From: [Kristen McNeill](#)
To: [Joe Bongiorno](#); [Bill Parsons](#)
Cc: [Alan Tiefenbach](#); [Matthew Adams](#); [Jason Densmer](#)
Subject: RE: Questions for Chukar Ridge Final Plat
Date: Tuesday, November 24, 2020 1:52:57 PM
Attachments: [fhwa-perm-paver-tech-brief.pdf](#)
[ACHD BMP 34 - Permeable Paver Roadway.pdf](#)

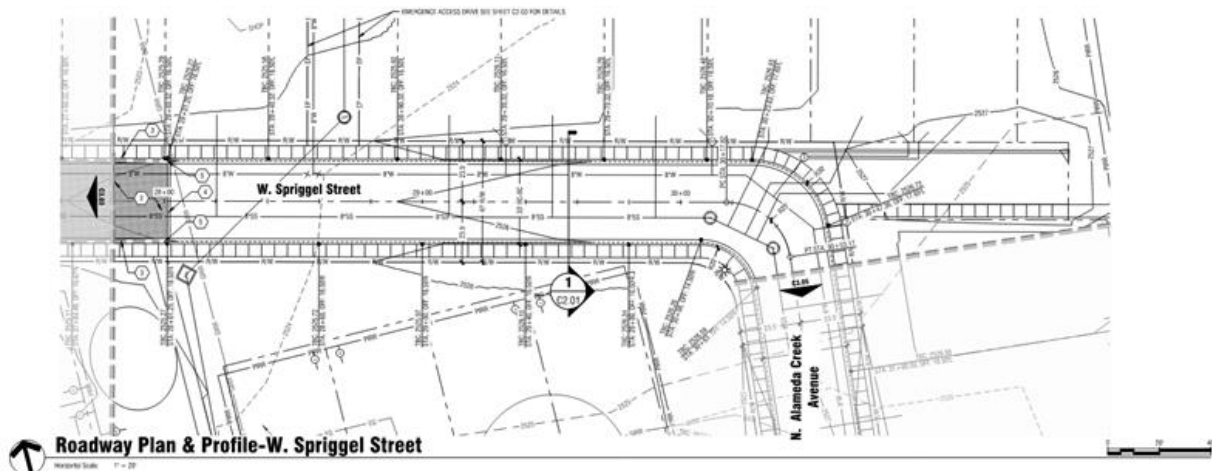
Radius Corner:

1. Can you send me the specifications for the Basalite pavers with the load capacity? It needs to be able to hold 80,000 pounds.
2. Can you overlay a 28'/48' turning radius on this corner? Just want to make sure we can make it with an 8.5' radius corner:

Regarding the 8.5' radius corner: That was changed to 20' radius and should be updated in the drawing sets submitted. Did you find that on a previously submitted set or is there a discrepancy in the drawings we submitted? I looked but didn't find the detail you showed in your email. Here is a snapshot of the current detail:
